Access Compliance Report

Public Rights-of-Way

(Curb Ramps)

Intersection ID: 21038	Main Street: BROCKTON_LN	Cross Street: PROVIDENCE_RD	Location: SW
ADA ID: 04A46A91F6F9	Ramp Type: BlendTrans2	Initial Pass/Fail: Fail	Overall Compliance: No
Severity Score: 8.75			
Codes/Mitigation Info/Possible Solution		Field Measurements/Component Compliance

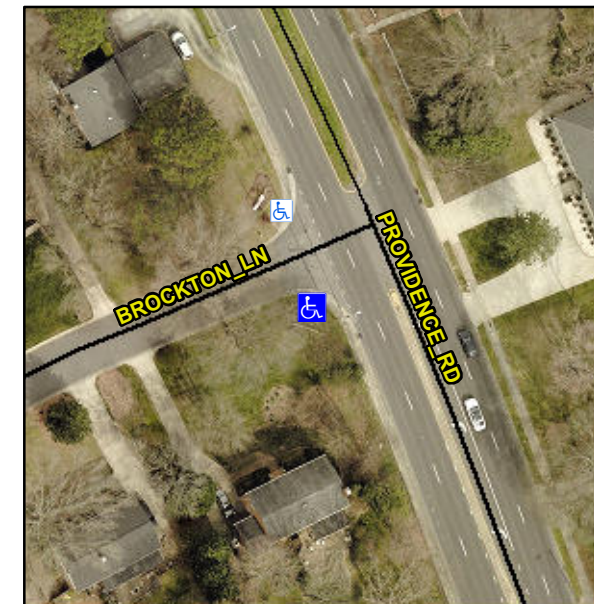
Not Found, R304.5.1

Compliance	Description	Data	Compliance	Description	Data
N/A	Ramp Length (in)	62.0	Yes	BlendTrans Slope (%)	3.6
No	Ramp Width (in)	47.0	Yes	BlendTrans XSlope (%)	1.9
N/A	Flare Type LT	N/A	N/A	Flare Type RT	N/A
N/A	Flare Slope LT (%)	N/A	N/A	Flare Slope RT (%)	N/A
N/A	Flare Traversable LT?	N/A	N/A	Flare Traversable RT?	N/A
N/A	Landing Length (in)	N/A	N/A	DWS Provided?	N/A
N/A	Landing Width (in)	N/A	N/A	DWS Contrast?	N/A
N/A	Landing Slope (%)	N/A	N/A	DWS Length (in)	N/A
N/A	Landing X Slope (%)	N/A	N/A	DWS Full Width?	N/A
N/A	Landing Curb? (Y/N)	N/A	N/A	DWS Offset (in)	N/A
N/A	Shared Landing?	N/A			
N/A	Gutter Ponding?	N/A	N/A	Gutter Slope (%)	N/A
N/A	Gutter Lip Ht (in)	N/A	N/A	Gutter X Slope (%)	N/A
N/A	Painted X Walk1?	No	N/A	Painted X Walk2?	No
	X Walk 1 Direction	To NE		X Walk 2 Direction	To NW
	X Walk 1 Width (in)	N/A		X Walk 2 Width (in)	N/A
	X Walk 1 Slope (%)	5.6		X Walk 2 Slope (%)	3.0
	X Walk 1 X Slope (%)	2.9		X Walk 2 X Slope (%)	3.4

N/A	Ramp inside XWalk1?	N/A	N/A	Ramp inside XWalk2?	N/A
	Road Slope (%)	1.9		Clear Space?	N/A
	Road X Slope (%)	3.2	N/A	Clear Space to XWalk (in)	N/A
N/A	Any Obstructions?	N/A	N/A	Storm Grate/Utility Hazard?	N/A
	Obstruction Type			Storm Grate/Utility Type	
		N/A			N/A
			Yes	Surface Condition? (G/P)	Good
			No	Curb Slope (%)	15.5

Remove & Replace Curb Ramp With Two New Directional Ramps or Equivalent.
